**NOTICE OF A REGULAR MEETING
BONDURANT PLANNING AND ZONING COMMISSION
AUGUST 11, 2022**

**BUSINESS OF THE PLANNING AND ZONING COMMISSION
BONDURANT, IOWA
AGENDA STATEMENT**

TITLE: -RESOLUTION NO. PZ-220811-23: Considering recommended approval of the site plan at 3410 Henry Street SW

WISTERIA CROSSING
BONDURANT, IA

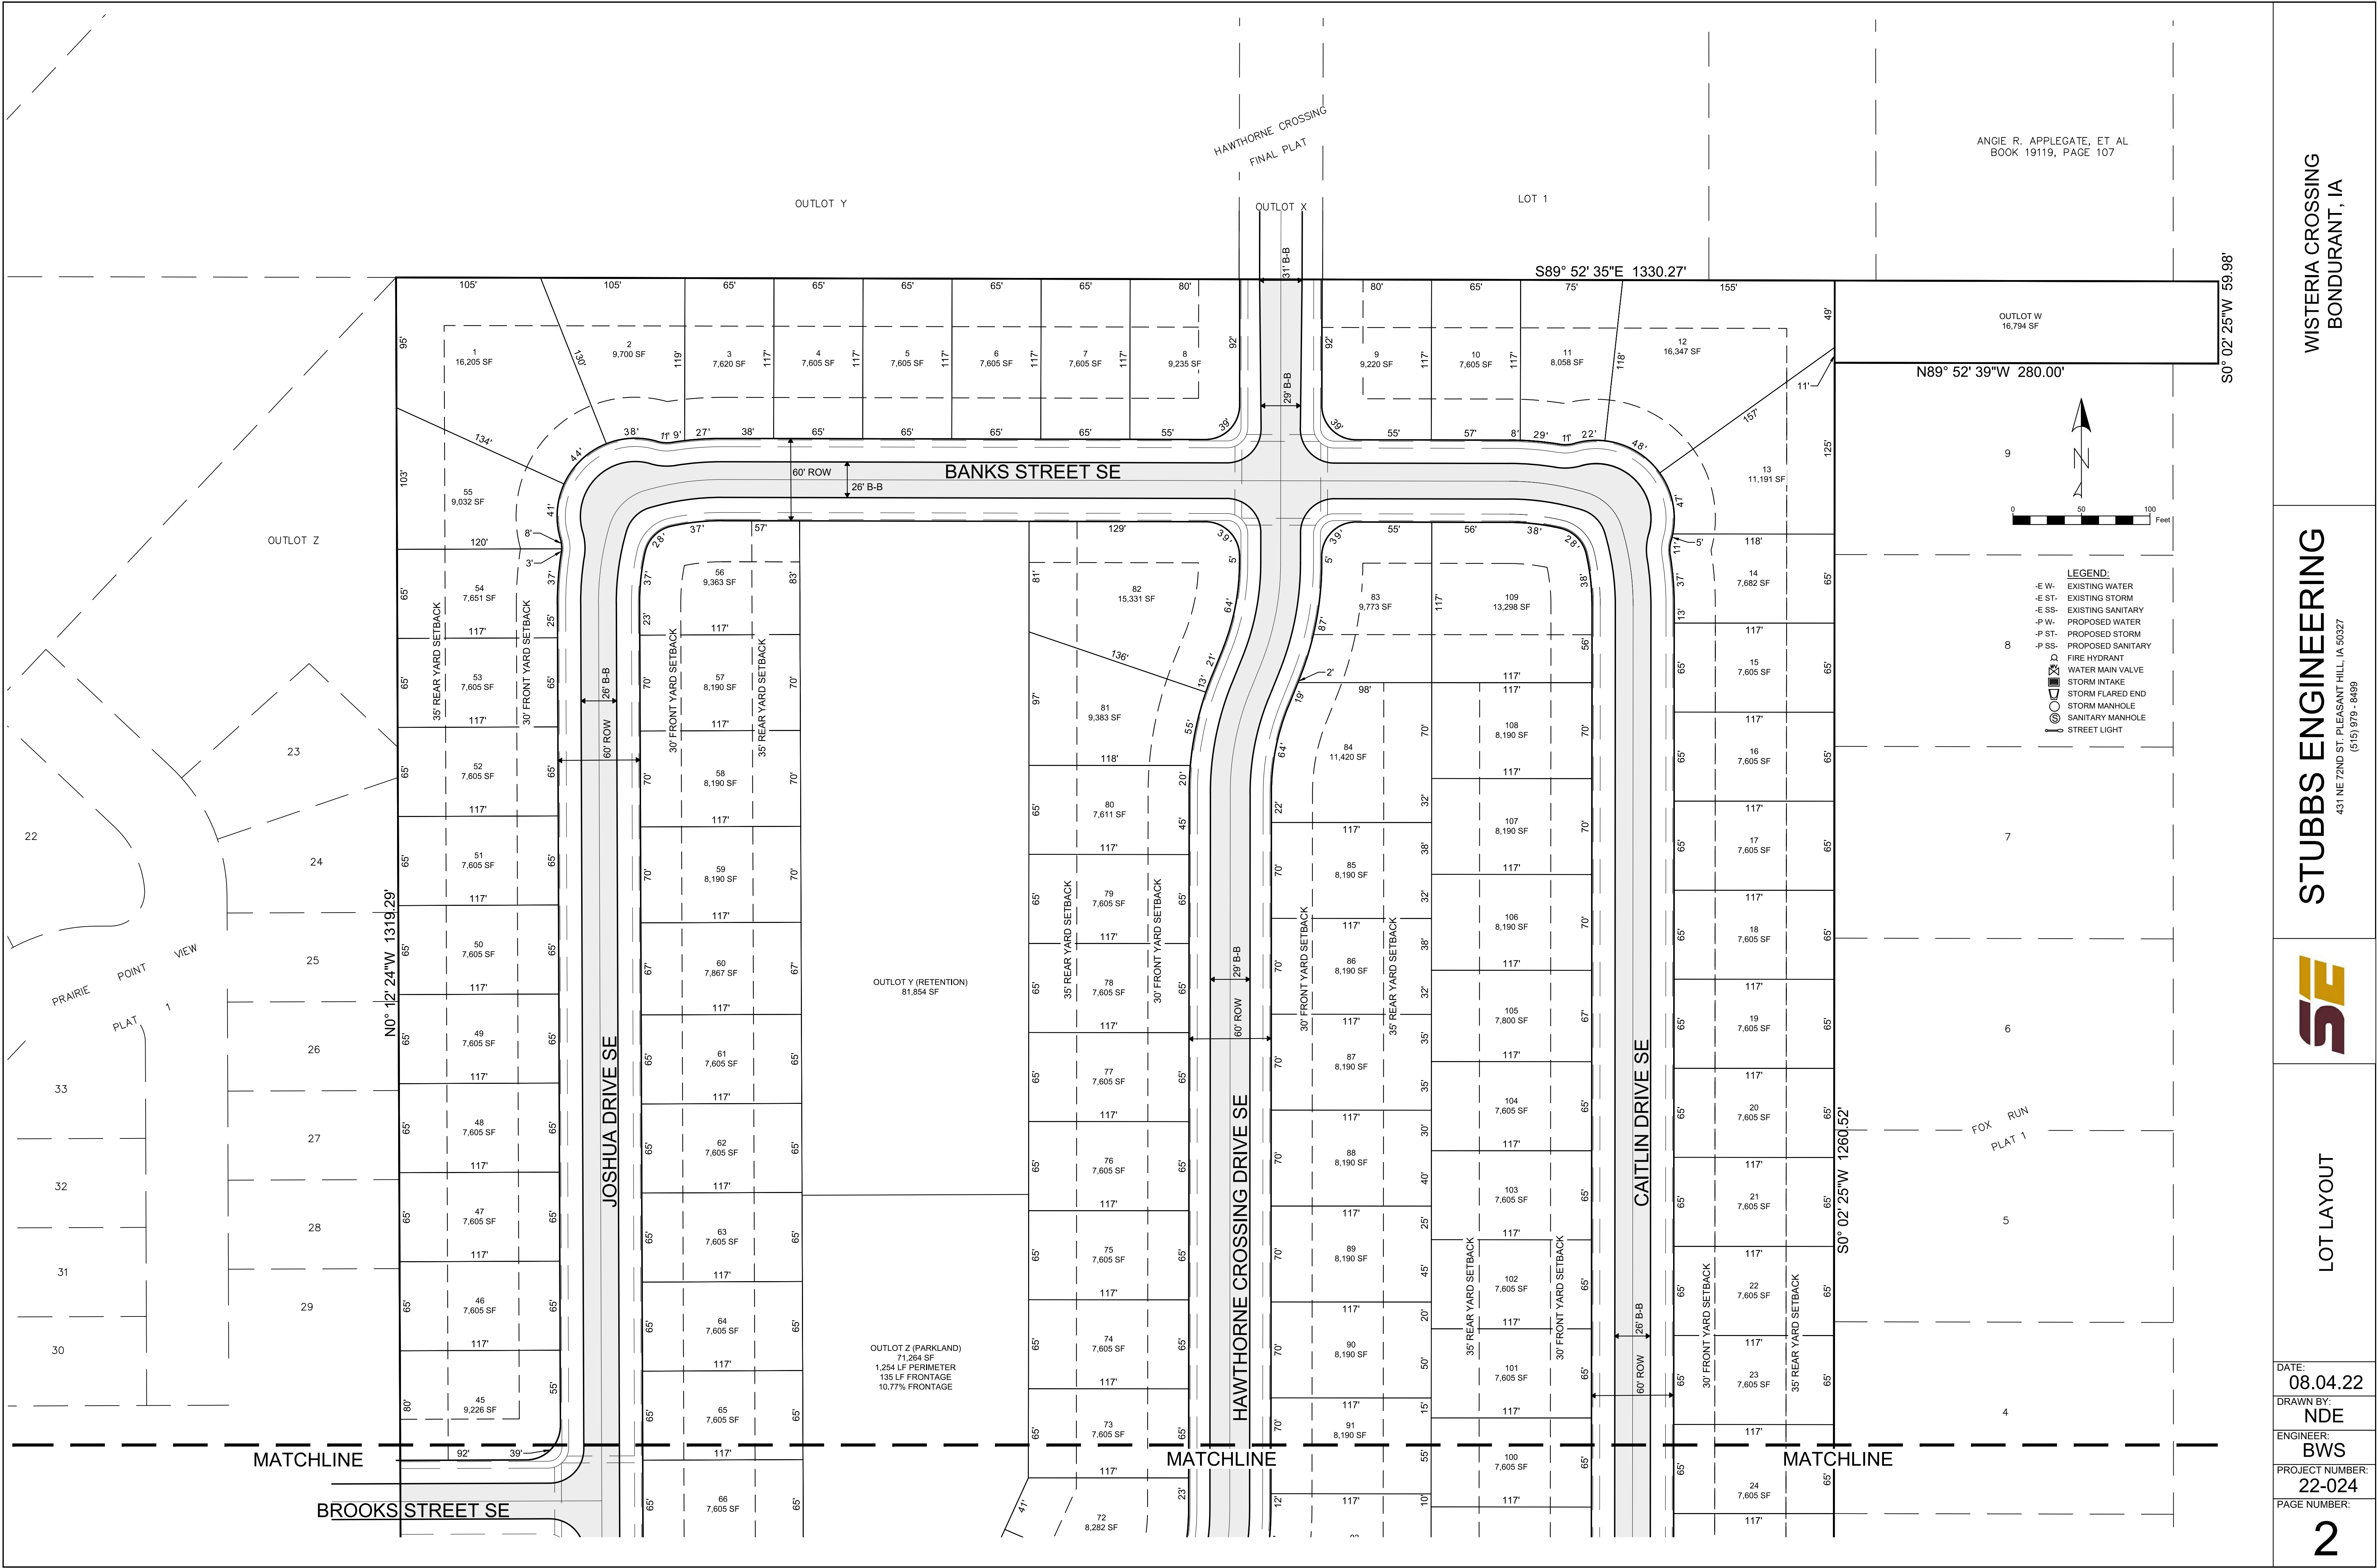
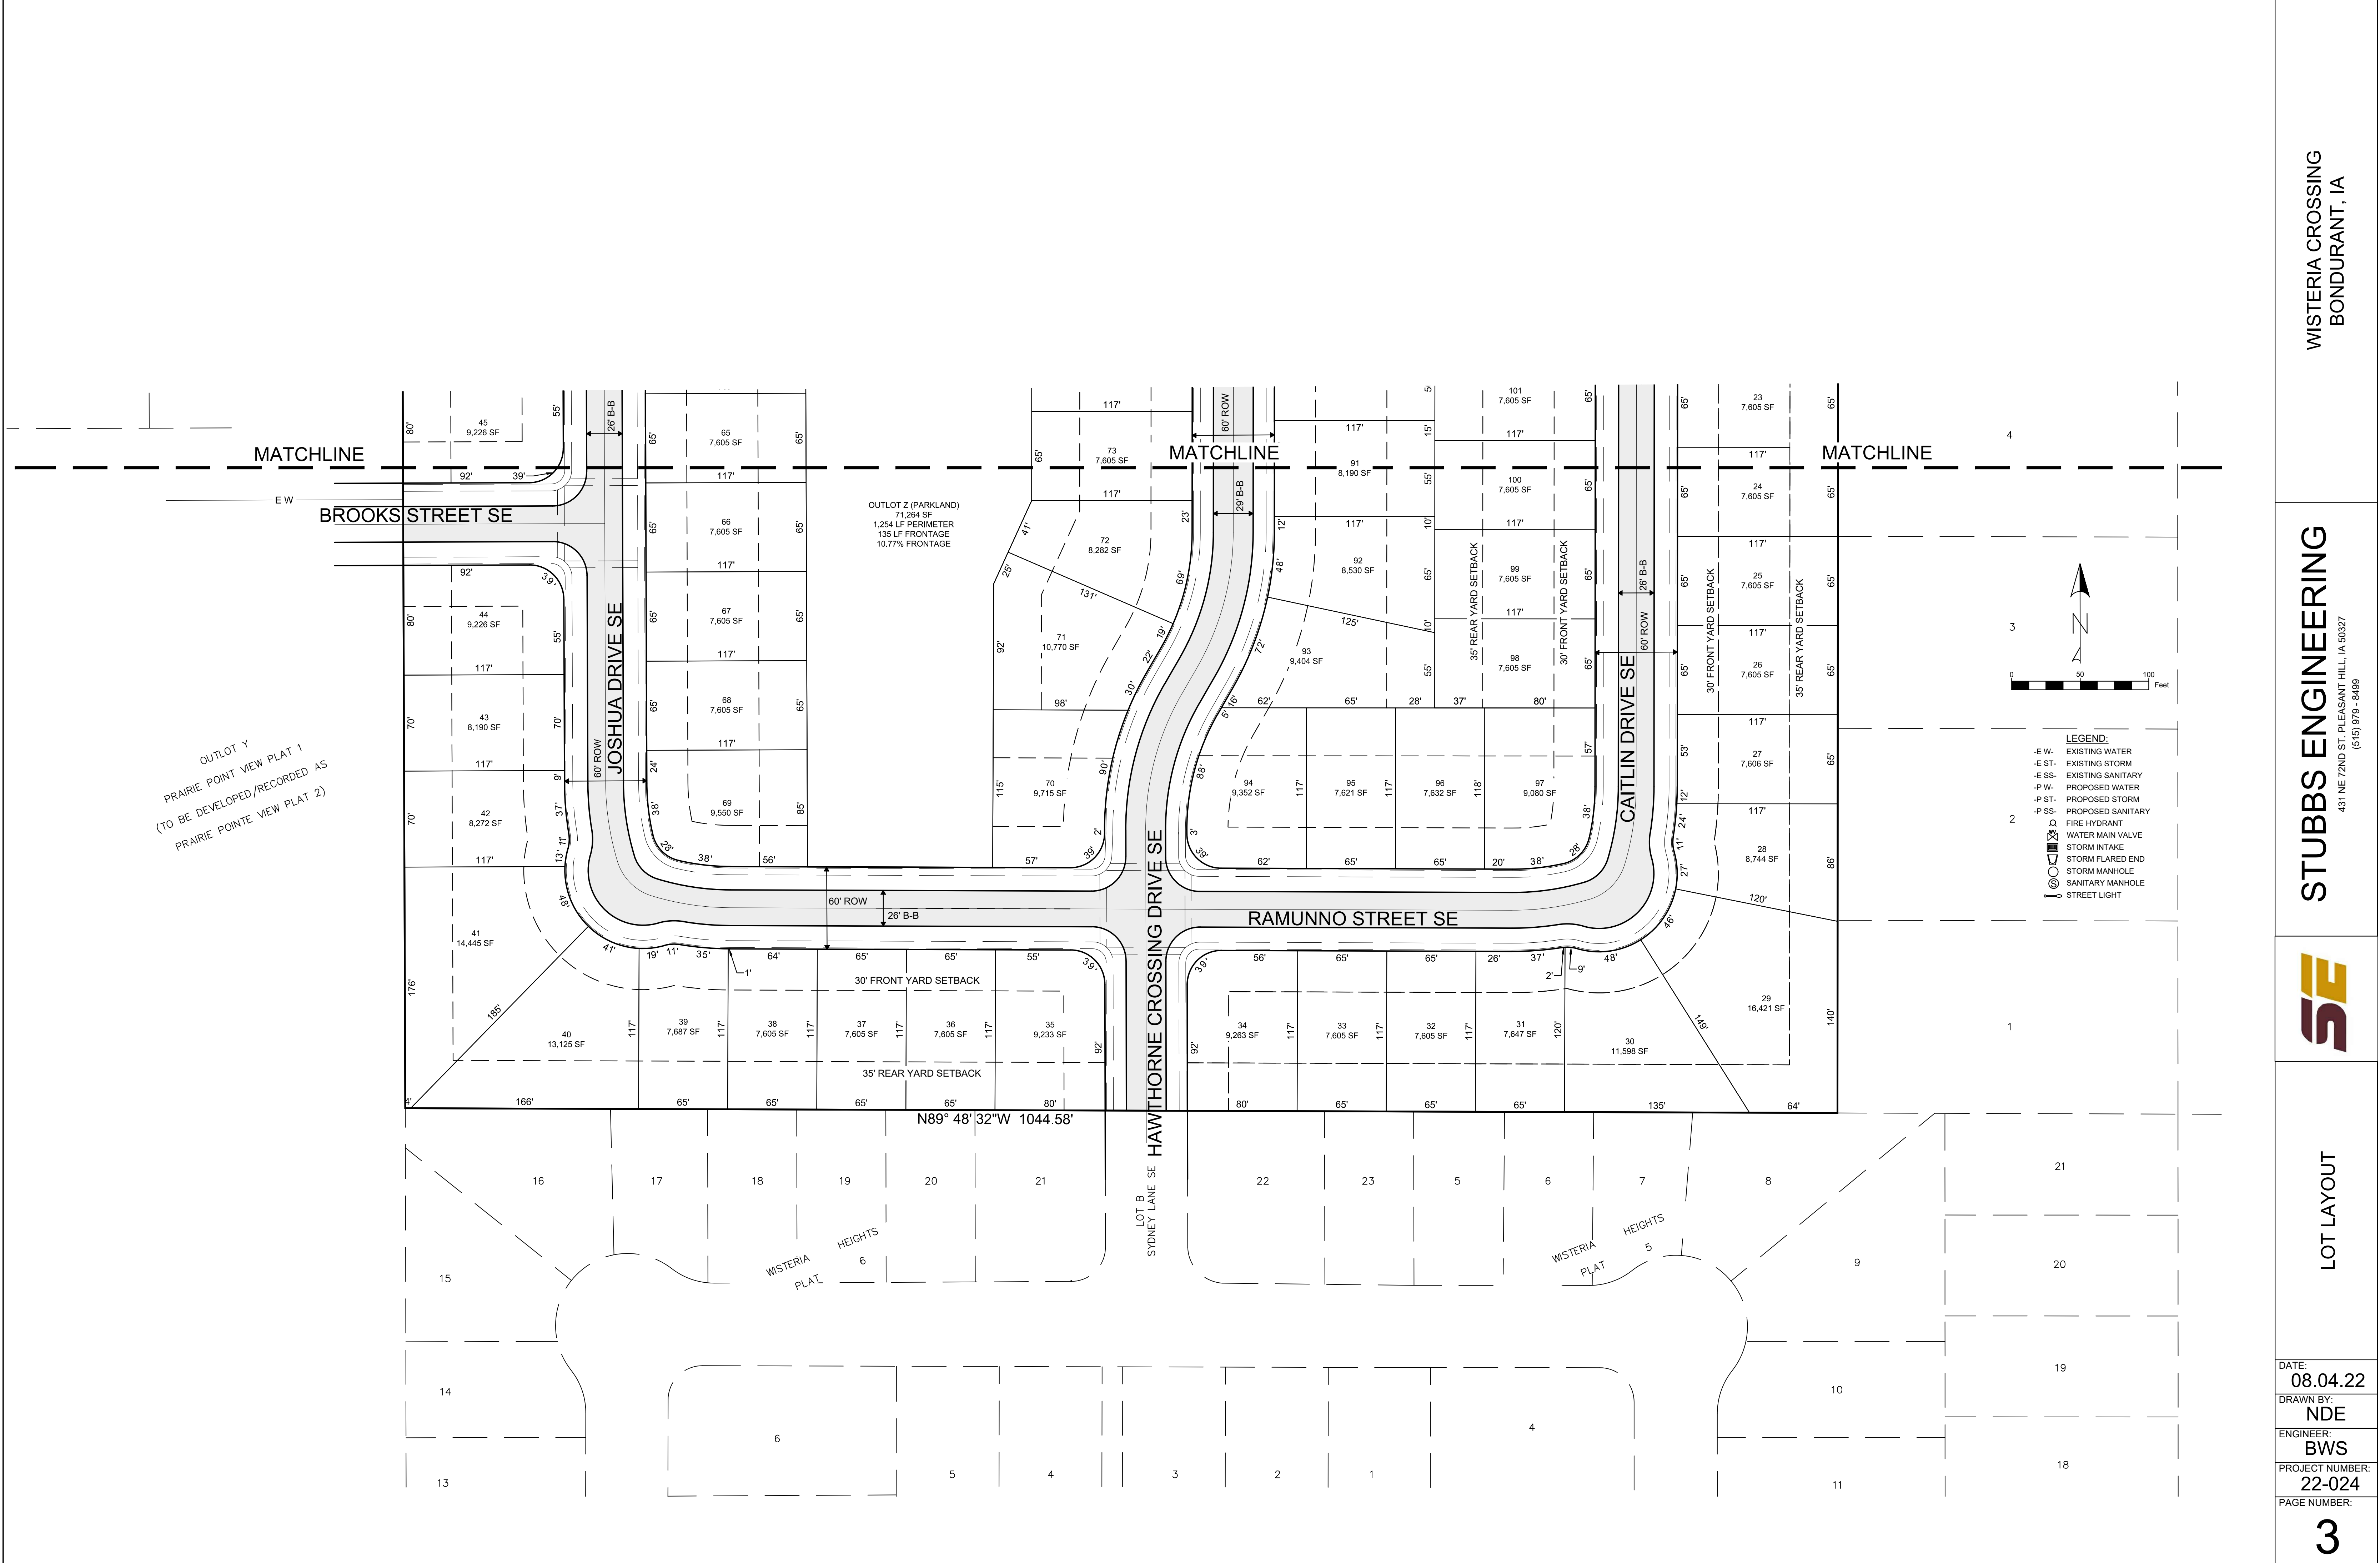
BRIEF HISTORY & ANALYSIS: The Planning & Zoning Commission tabled their review of the Wisteria Crossing Preliminary Plat during their meeting on July 28, 2022. The developer has since resubmitted the attached 3 versions of the Wisteria Crossing Preliminary Plat for the Commission's review. These options are summarized below.

- **Option 1** - this option proposes 109 lots. This option proposes one, 1.64-acre park with 10.77% of its park boundary fronting a public street. This 10.77% meets the Code's minimum requirement of 10%. This option does not show a street connection on Outlot W east over to Pleasant Street SE as requested by the Planning & Zoning Commission.

- **Option 2** - this option proposes 107 lots. This option proposes one, 1.64-acre park with 10.77% of its park boundary fronting a public street. This option does show a street connection on Outlot W east over to Pleasant Street SE as requested by the Planning & Zoning Commission.

- **Option 3** - this option 108 lots. This option proposes a 1.88-acre park with 22.65% of its park boundary fronting a public street. This option does not propose a street connection on Outlot W east over to Pleasant Street SE as requested by the Planning & Zoning Commission.
